SUBDIVISION REVIEW SHEET**CASE NO.:** C8-2019-0185.0A**COMMISSION DATE:** February 11, 2020**SUBDIVISION NAME:** Armadillo Parks resubdivision**ADDRESS:** 901 and 906 Armadillo Road**APPLICANT:** David Cox (Verde Ville, LLC)**AGENT:** George Gonzalez (Genesis 1 Engineering Co.)**ZONING:** SF-3-NP (single family residence)**NEIGHBORHOOD PLAN:** Garrison Creek**AREA:** 0.703 acre (30,642 sf)**LOTS:** 5**COUNTY:** Travis**DISTRICT:** 2**WATERSHED:** Gilliland Creek**JURISDICTION:** Full Purpose**SIDEWALKS:** Sidewalks will be constructed along Armadillo Road, Cooper Lane and Antelope Circle.**VARIANCES:** A variance to LDC 25-8-641 (heritage tree removal) is required, but was not submitted.**DEPARTMENT COMMENTS:**

ARMADILLO PARKS

CITY OF AUSTIN –DEVELOPMENT SERVICES DEPARTMENT
SUBDIVISION APPLICATION – MASTER COMMENT REPORT

PROJECT NAME: Armadillo Parks - Resubdivision
LOCATION: 901 ARMADILLO RD

Exhibit B: Proposed plat

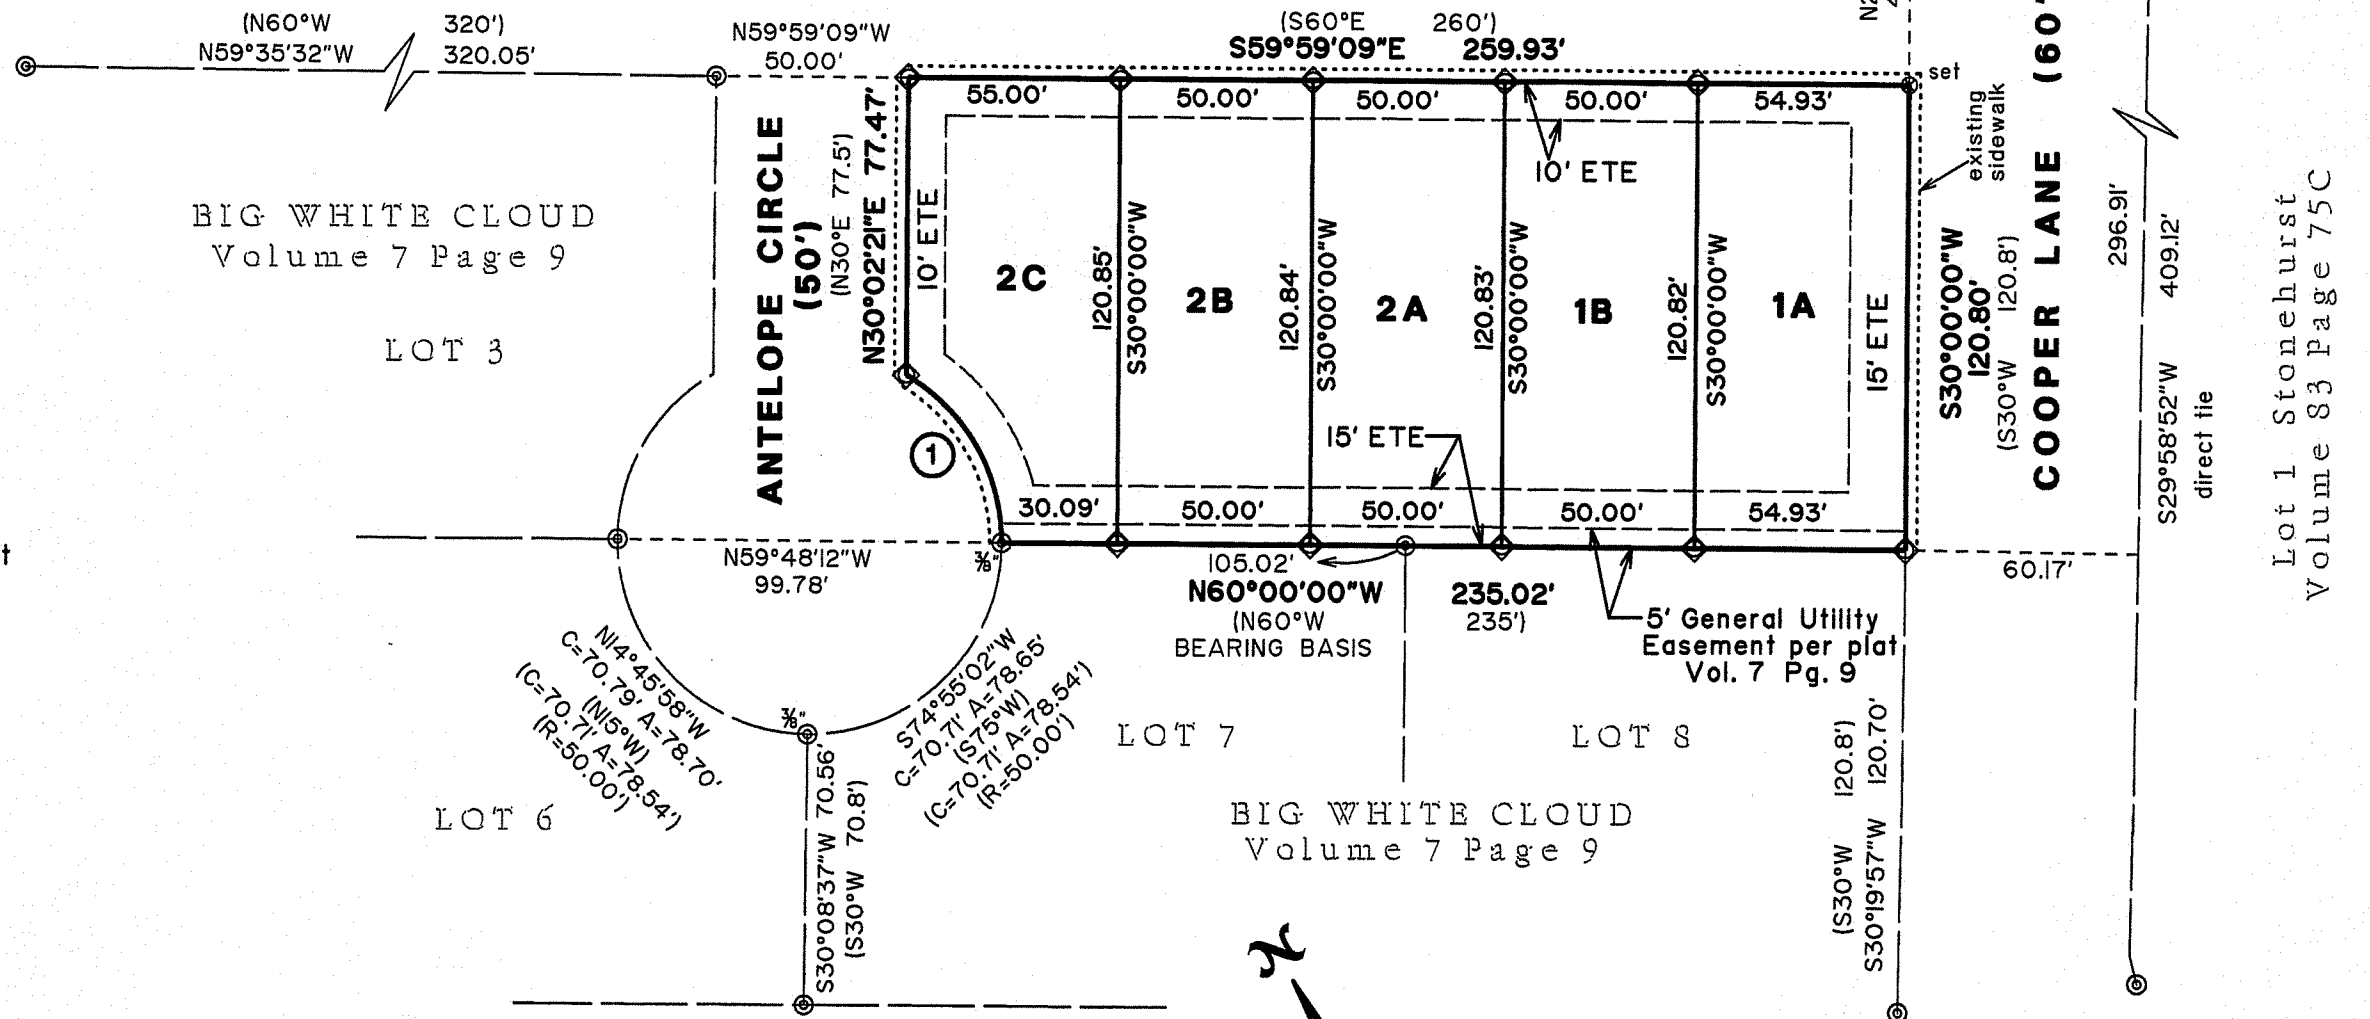
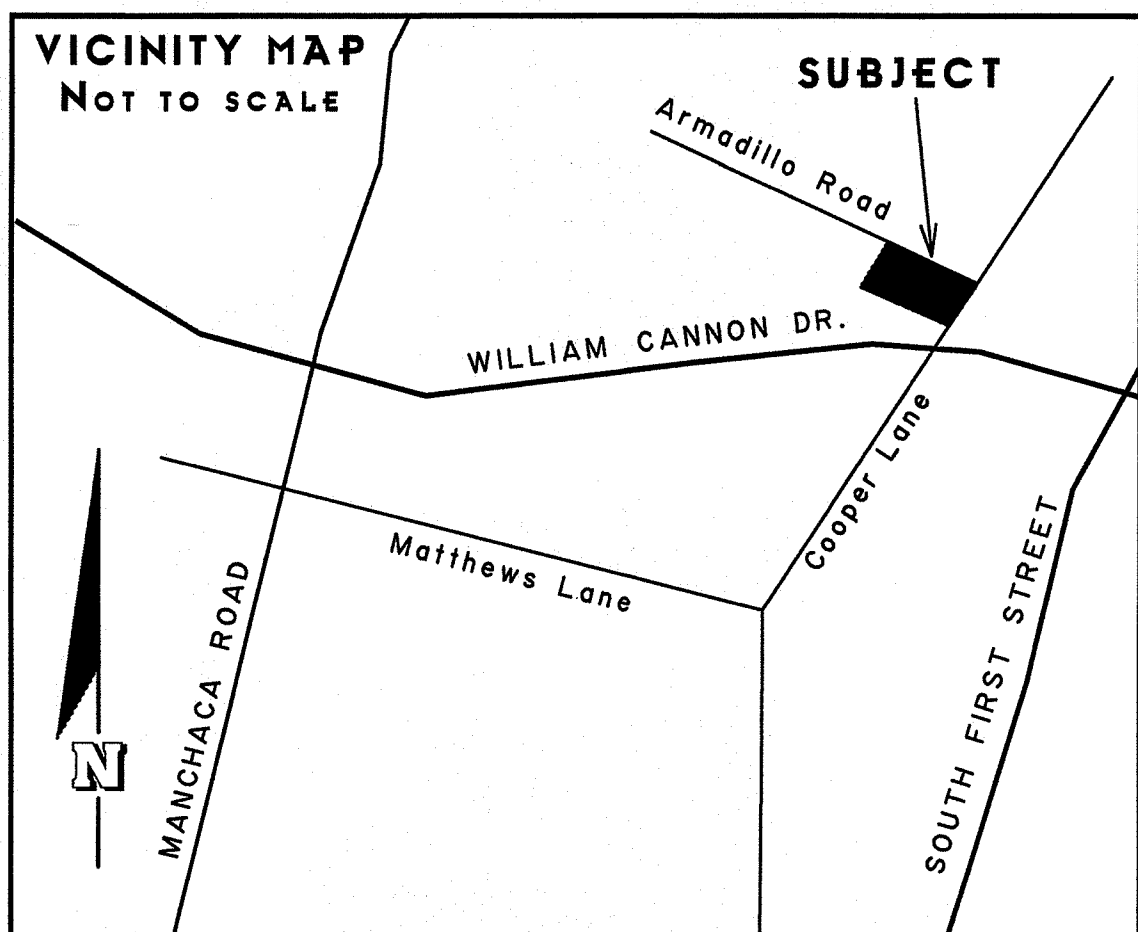
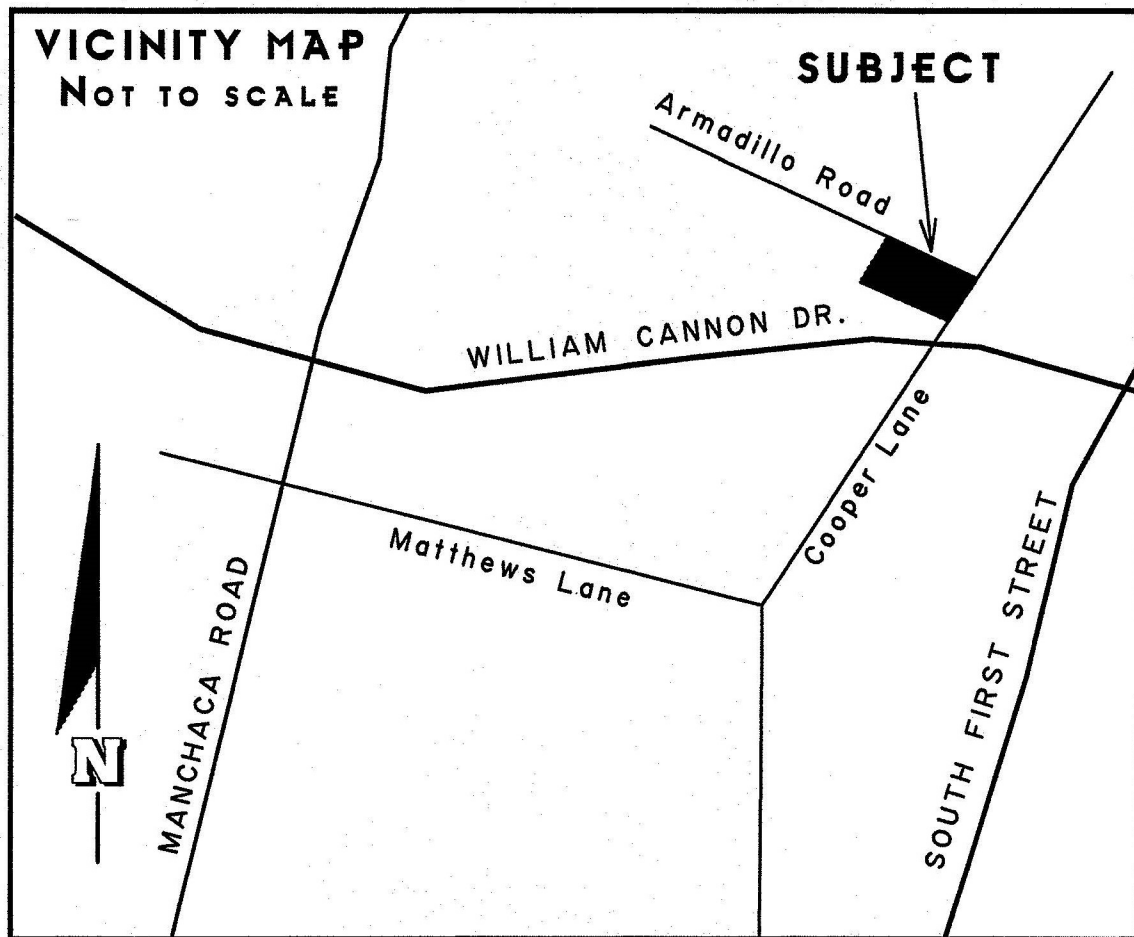
- SR 1. Add the Case #C8-2019-0185.0A in the bottom right hand corner of each sheet. (§ 25-1-83)
- SR 2. Revise the jurisdiction note as follows (§ 25-1-83):
 "This subdivision plat is located within the full purpose jurisdiction of the City of Austin on this the _____ day of _____, 2020.

- SR 3. Replace the ZAP approval block with the following (§ 25-1-83):
 Accepted and authorized for record by the Land Use Commission of the City of Austin, Texas, on this, the _____ day of _____, 2020.

- SR 6. If fiscal is required, delete note 13 and replace it with the following note (§ 25-4-84):
 "This subdivision plat was approved and recorded before the construction and acceptance of streets and other subdivision improvements. Pursuant to the terms of a Subdivision Construction Agreement between the subdivider and the City of Austin, Dated _____, 2020, the subdivider is responsible for the construction of all streets and facilities needed to serve the lots within the subdivision. This responsibility may be assigned in accordance with the terms of that agreement. For the Construction Agreement pertaining to this subdivision, see the separate instrument recorded in Doc#. _____, in the Official Public Records of Travis County, Texas."

- SR 7. Revise the administrative approval block (§ 25-1-83):
 APPROVED, ACCEPTED AND AUTHORIZED FOR RECORD BY THE DIRECTOR,
 DEVELOPMENT SERVICES DEPARTMENT, CITY OF AUSTIN, COUNTY OF TRAVIS, THIS
 THE ____ DAY OF _____, 2020, AD.

- CA1 The plat does not comply with Chapter 25-8, Article 1. The reasons for noncompliance are listed below.
- CA2 There are multiple heritage trees proposed to be removed. The proposed removal of heritage trees is not allowed by code. Either redesign or request a variance from LDC 25-8-641. For trees with a single stem at least 30" the variance process requires a public hearing before the Environmental Board and Land Use Commission to determine if the trees can be removed.

- CA7 Hatch heritage trees on the plan sheets. (ECM, Section 3; § 25-1-83)
- CA8 Show removed trees with dashed concentric circles per ECM, Section 3 and § 25-1-83.
- CA9 Show preserved trees with solid concentric circles per ECM, Section 3 and § 25-1-83.
